DESCRIPTIVE REPORT

Registry No. H-11240

General Locality Kasaan Bay

Sublocality Polk Inlet

New Rocks found from bathymetry (circled red) in Chart

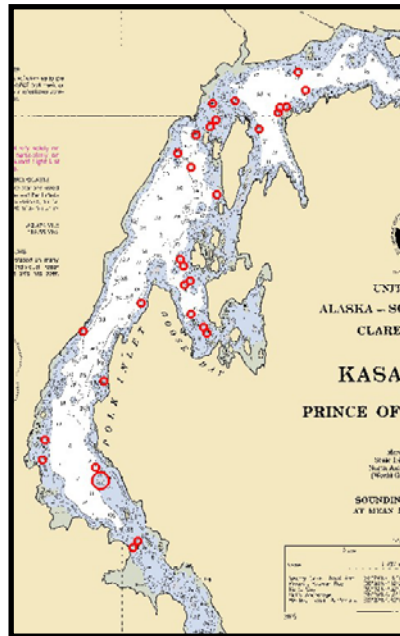
There are seven¹⁸ new rocks identified in this survey from bathymetry.¹⁹ The following is a list of their positions and depths.

Based on the results of survey H-11240, the Hydrographer recommends updating the next editions with the rocks listed.³⁵

¹⁸ Strikethrough ~~seven~~, replace with “twenty”.

- ³⁵ Concur with clarification. Chart new rocks according to the smooth sheet and Hdrawing.
- ³⁶ Strikethrough *is*, replace with “are”.
- ³⁷ Concur.
- ³⁸ Concur with clarification. After PHB review, a 1 fm 2 ft sounding at Lat 55° 25' 04.8"N, Lon 132° 28' 09.3"W and 2 fm 3 ft sounding at Lat 55° 24' 50.9"N, Lon 132° 28' 50.0"W, were submitted as Dangers to Navigation. See Appendix I, Danger to Navigation Report, attached to this report.

Detail of 5-and 10-fathom curve on Chart 17426, denoted by the blue rectangle

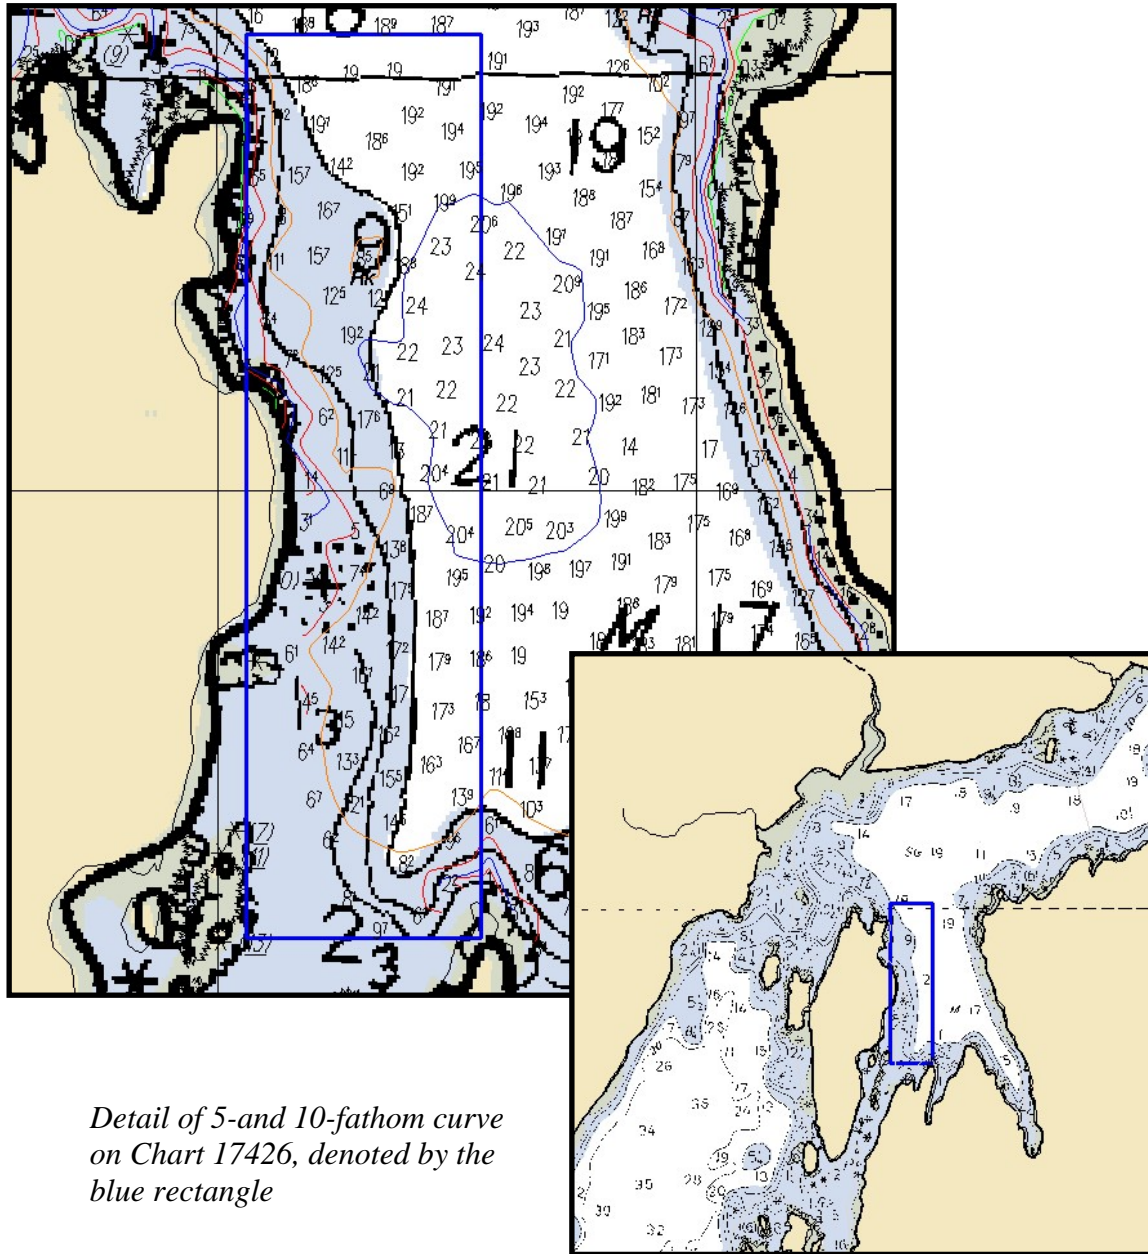
A review of the soundings and chart shows that the 2003 5- and 10-fathom curves in the vicinity below is³⁶ significantly different then the charted curve.

Based on the results of survey H-11240, the Hydrographer recommends updating the next editions using the 2003 soundings to adjust the 5- and 10-fathom curves in the location above.³⁷

- ³⁹ Strikethrough *2*, replace with “1”.
- ⁴⁰ Concur with clarification. Due to scale, the 1 fathom curve has not been depicted on the Hdrawing. Chart according to the Hdrawing.

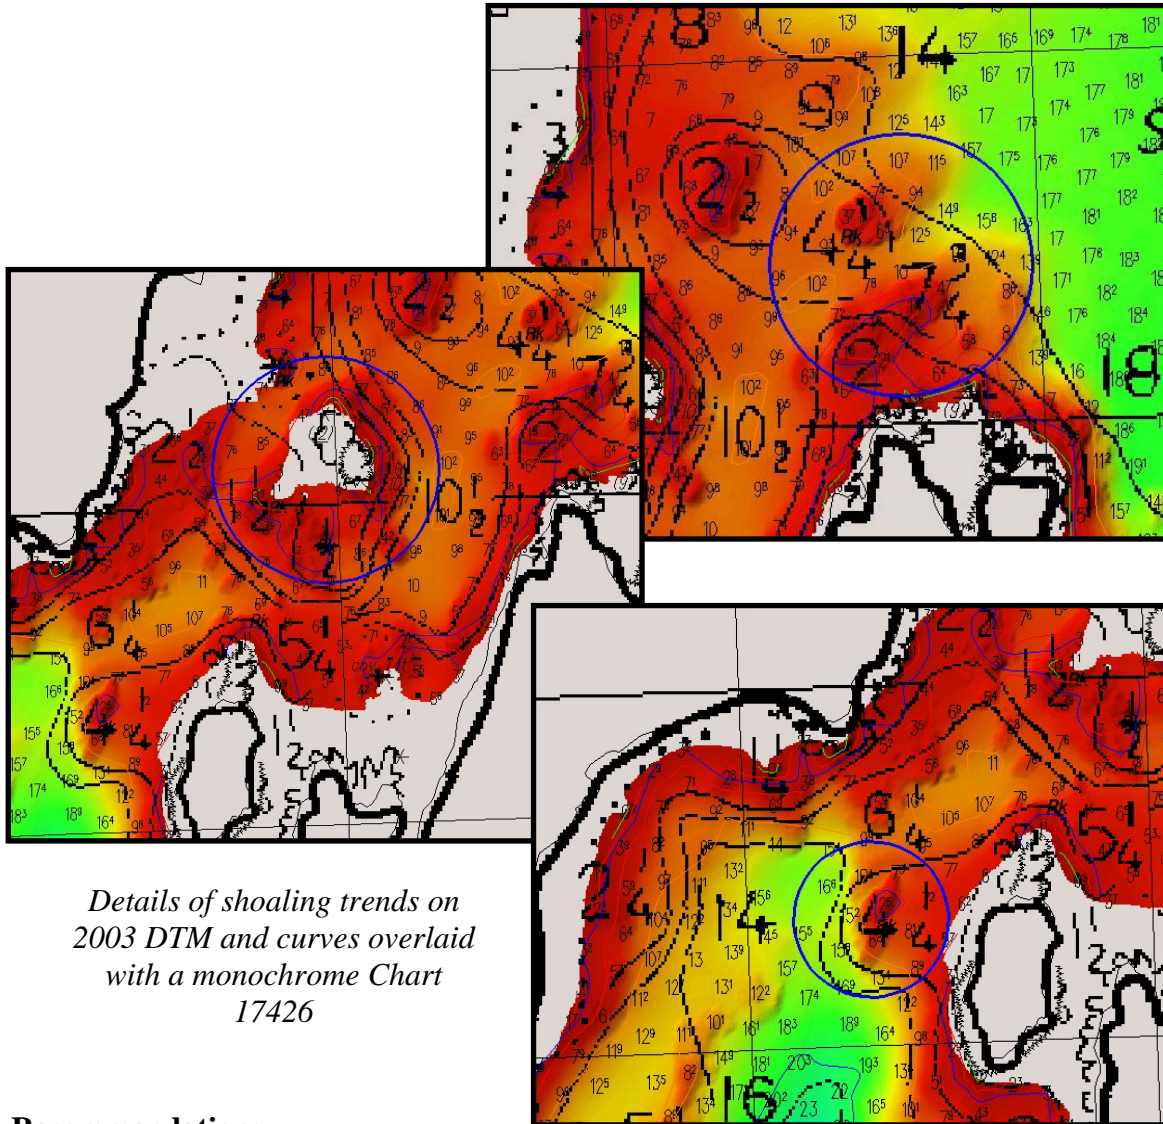
A review of the soundings and chart shows shoaling areas at the entrance to Polk Inlet. The change ranges from 1.5 to 3-fathoms shoaler than charted. A danger to navigation report has been submitted.³⁸

Based on the results of survey H-11240, the Hydrographer recommends updating the next editions using the 2003 soundings to adjust the 2,³⁹ 3 and 5-fathom curves in the above area.⁴⁰ The areas are located at approximately 55° 25' 07"N and 132° 28' 11"W , 55° 24' 51"N and 132° 28' 50"W and 55° 20' 13"N and 132° 22' 01"W.⁴¹

- ⁴¹ The third position is incorrect. Strikethrough ~~55° 20' 13"N and 132° 22' 01"W~~, replace with 55° 25' 06.76" and 132° 28' 34.24".
- ⁴² Concur. Chart according to the smooth sheet.

Chart 17426, Location of 10.8- fathom depth

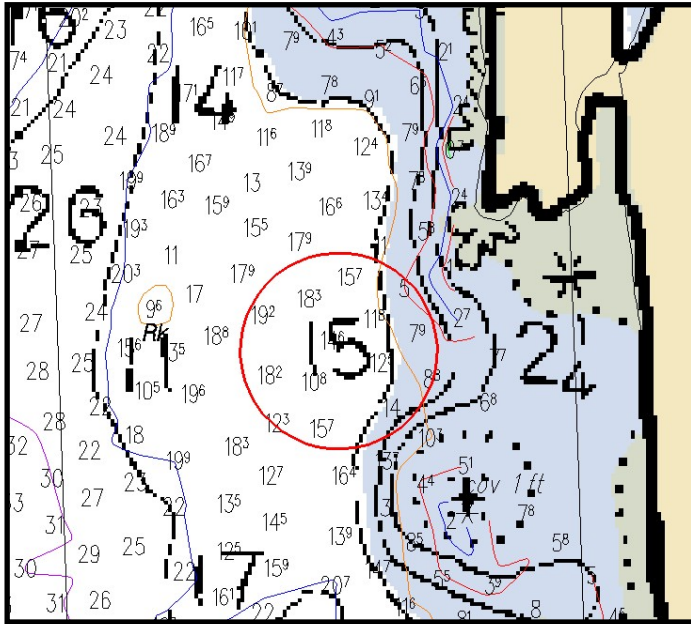
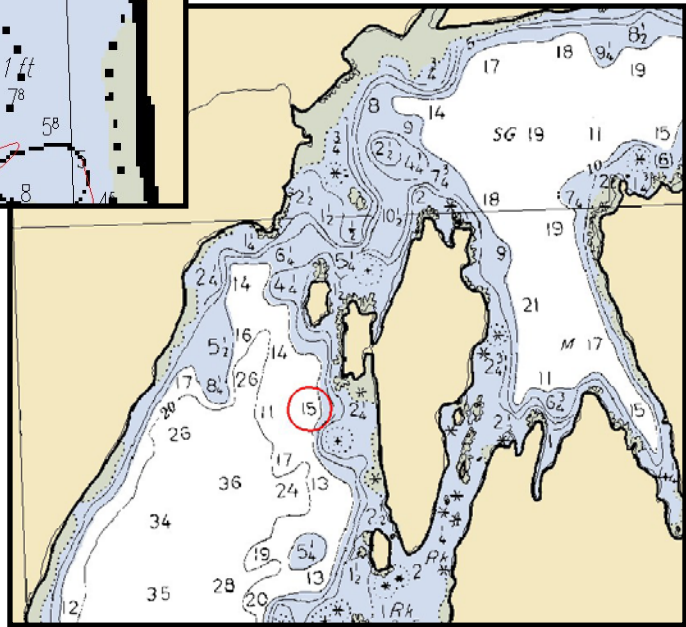
A review of the soundings and chart shows a 2003 10.8 fathom sounding on the charted 15-fathom depth.

Based on the results of survey H-11240, the Hydrographer recommends replacing the 15-fathom sounding at 55° 24' 31"N and 132° 28' 46 "W with a 10-fathom sounding.⁴³

- ⁴³ Concur with clarification. Chart 10 fm 5 ft at smooth sheet position.
- ⁴⁴ Concur with clarification. This sounding was submitted as a Danger to Navigation. See Appendix I, Danger to Navigation Report, attached to this report. Chart 4 fm 3 ft at smooth sheet position.

Chart 17426, Location of 5 ¼-fathom depth

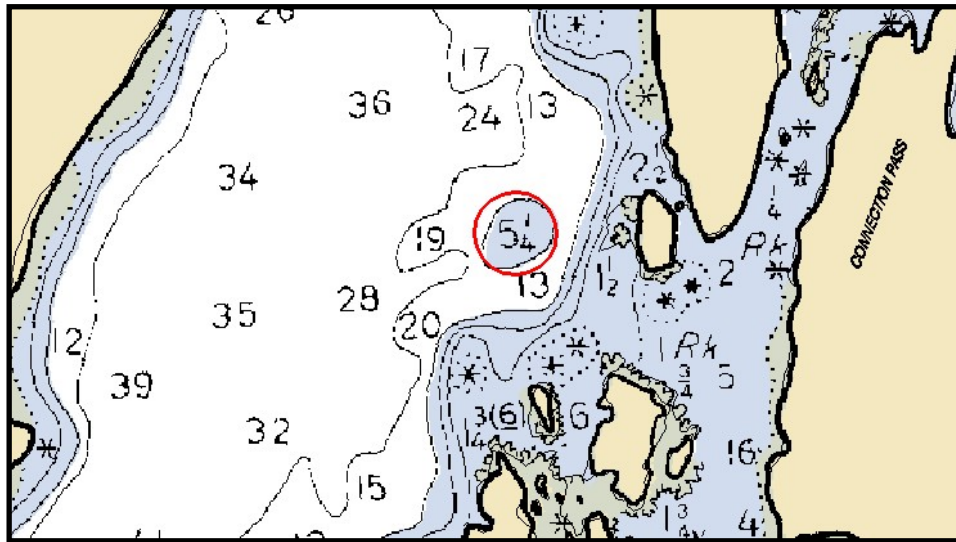
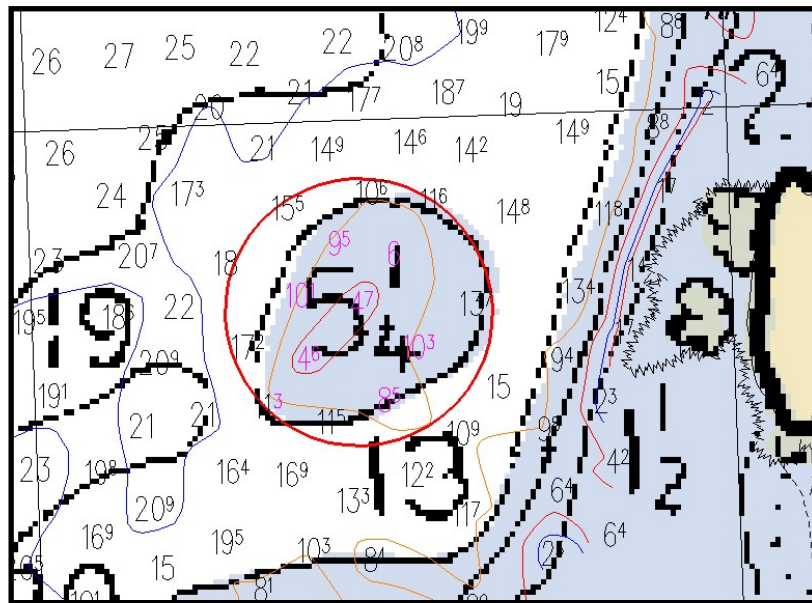
A review of the soundings and chart shows a 2003 4.6 fathom sounding on the charted 5¼-fathom depth.

Based on the results of survey H-11240, the Hydrographer recommends replacing the 5 ¼-fathom sounding at 55° 24' 09"N and 132° 28' 48 "W with a 4½-fathom sounding.⁴⁴

Location of charted 12-fathom depth on Chart 17426

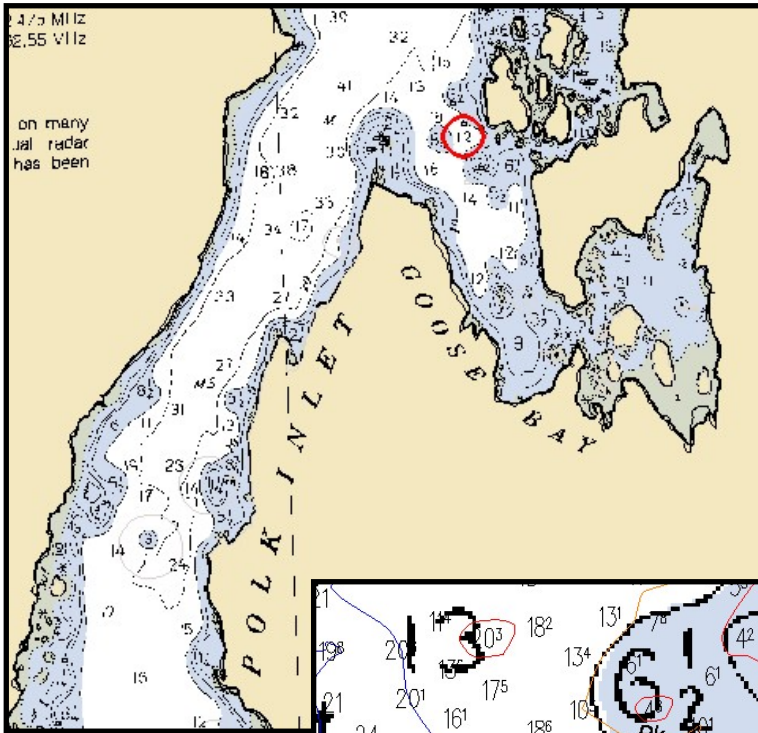
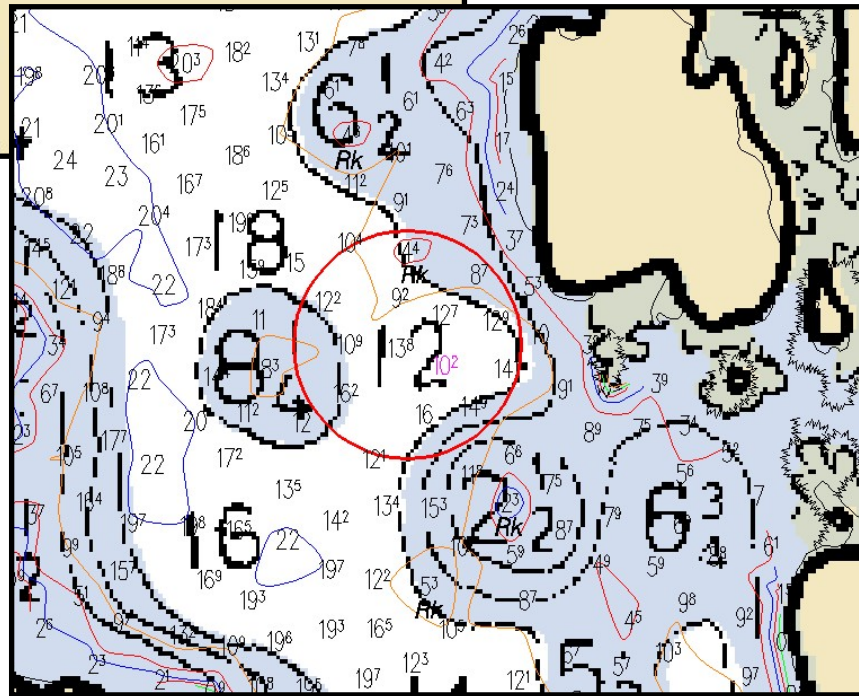
A review of the soundings and chart shows a 10.2 fathom sounding on the charted 12-fathom depth.

Based on the results of survey H-11240, the Hydrographer recommends replacing the 12-fathom sounding at 55° 23' 37"N and 132° 29' 00 "W with a 10-fathom sounding.⁴⁵

- ⁴⁵ Concur with clarification. Chart 10 fm 1 ft at smooth sheet position.
- ⁴⁶ Concur with clarification. A depth of 0.6 fm was found near the position of the charted 1¼ fm *Rk*, Lat 55/22/37N, Lon 132/30/24W. The 0.5 fm sounding discussed is farther south at the position given. Both soundings are in an area denoted as *rky* on the smooth sheet. Chart the vicinity according to the smooth sheet and Hdrawing.

Location of charted 1¼-fathom depth on Chart 17426

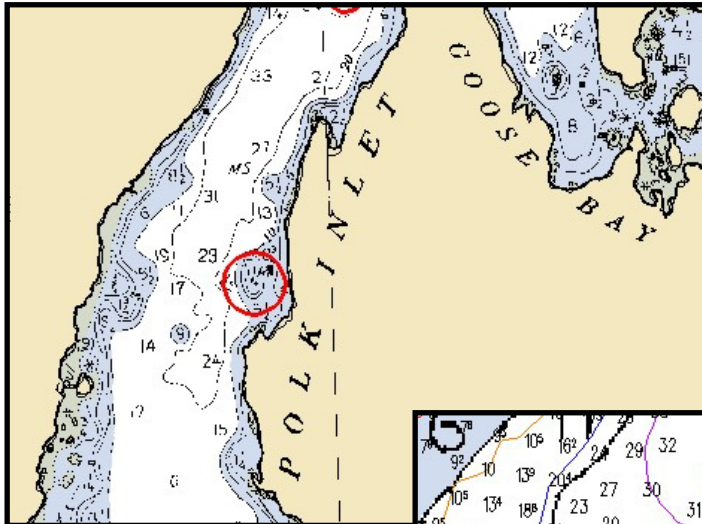
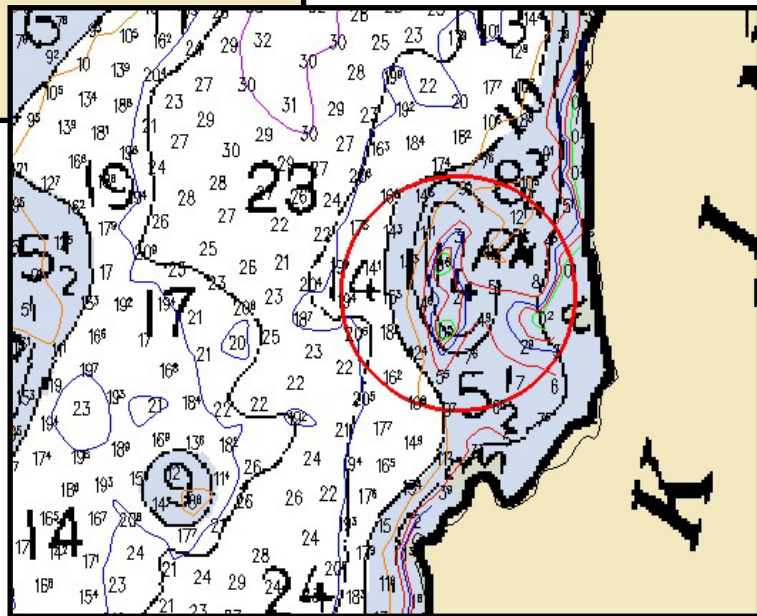
A review of the soundings and chart shows a 2003 0.5 fathom sounding on the charted 1 ¼-fathom depth.

Based on the results of survey H-11240, the Hydrographer recommends adjusting contours and replacing the 1¼- fathom sounding at 55° 22' 34"N and 132° 30' 24 "W with a 0½-fathom sounding.⁴⁶

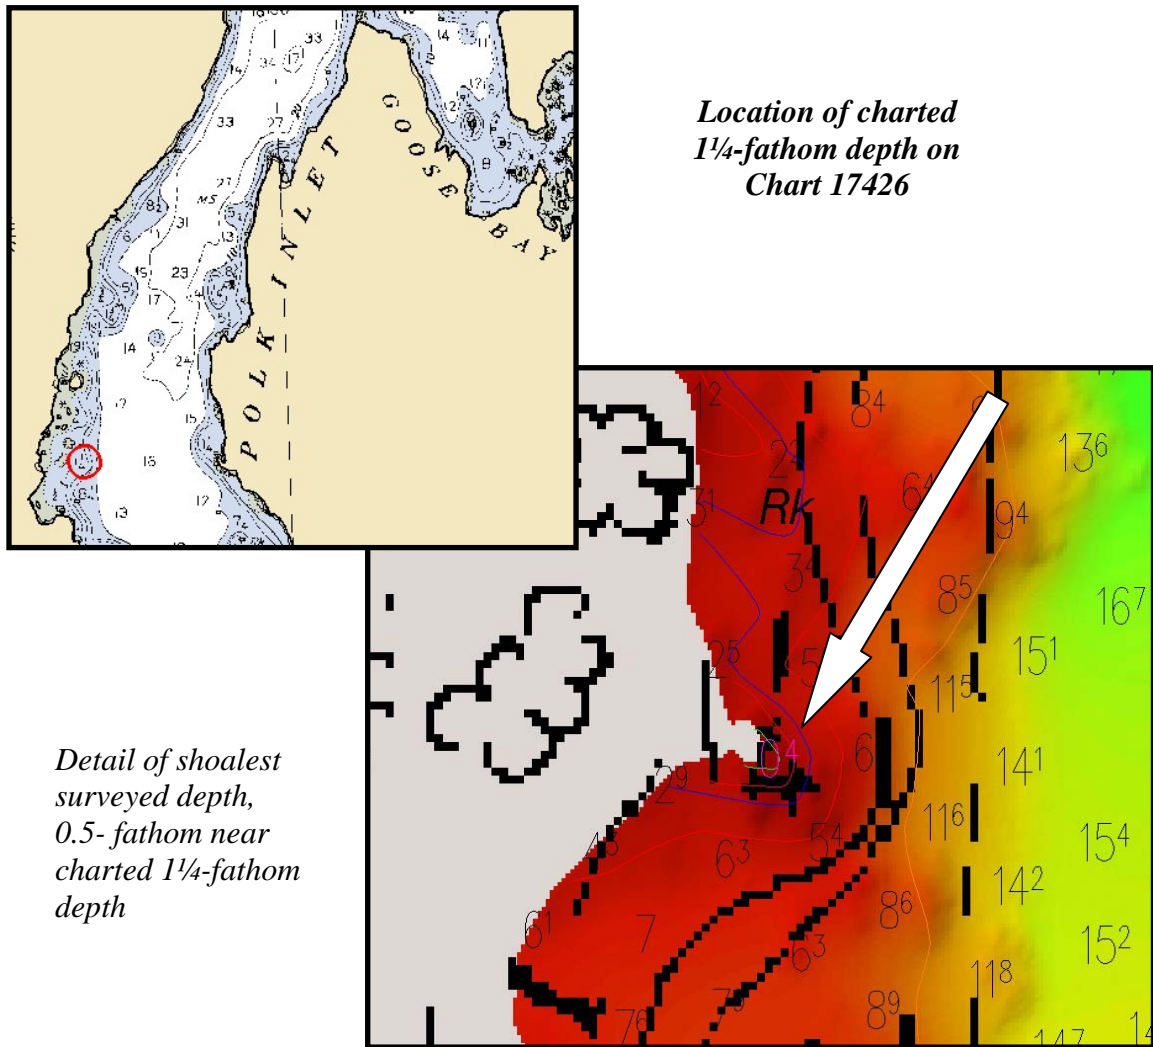
A review of the soundings and chart shows a 2003 0.4-fathom sounding on the charted 1¼-fathom depth.

Based on the results of survey H-11240, the Hydrographer recommends replacing the 1¼- fathom sounding at 55° 22' 03"N and 132° 31' 13 "W with a 0¼-fathom sounding.⁴⁷

- ⁴⁷ Concur with clarification. Chart 0 fm 2ft at smooth sheet position.
- ⁴⁸ Concur with clarification. Update shoreline with most recent verified RSD.

Chart 17420 showing the charted versus RSD shoreline discrepancy

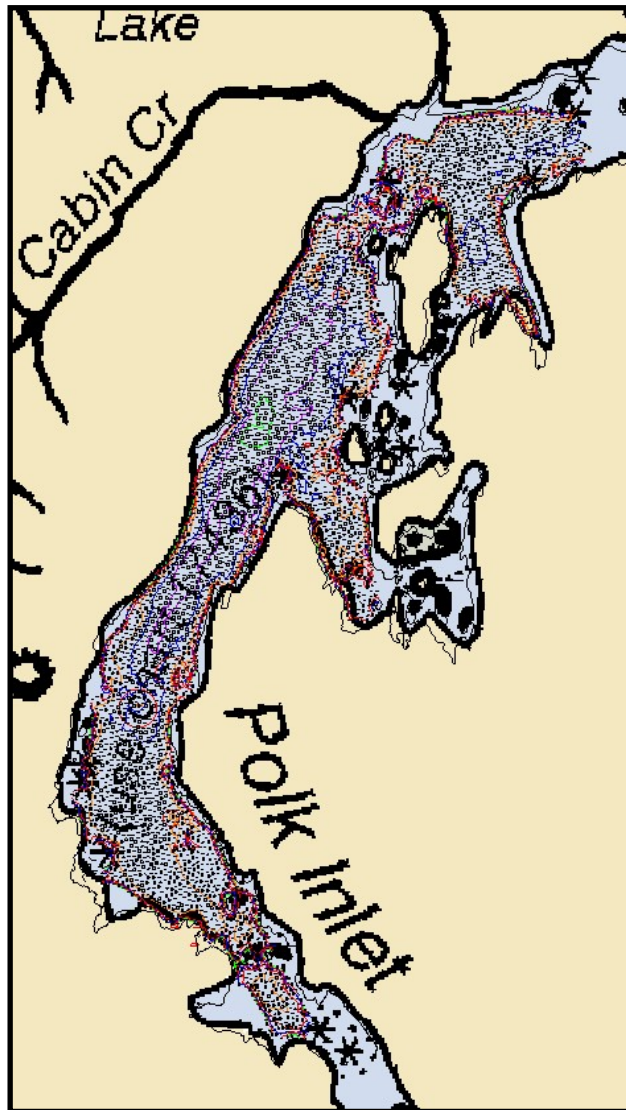
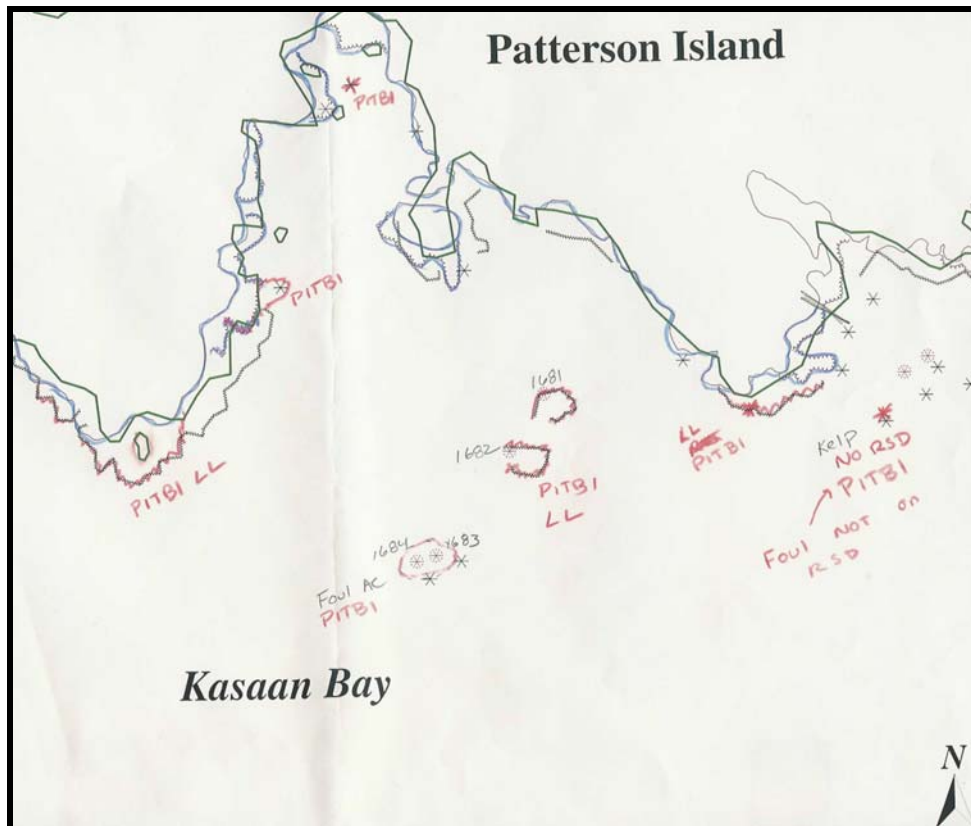
This survey generally agreed well with the chart. There are no soundings to compare to the 2003 survey. A comparison of the chart and remote sensing data does reveal a general discrepancy in the form of a shift in the shoreline. The charted shoreline is shifted overall to the north of the remote sensing data. The remote sensing data was verified through traditional and limited methods during this survey and was found to be accurate.

The newest edition of Chart 17420 should be adjusted to the 2003 RSD shoreline data.⁴⁸
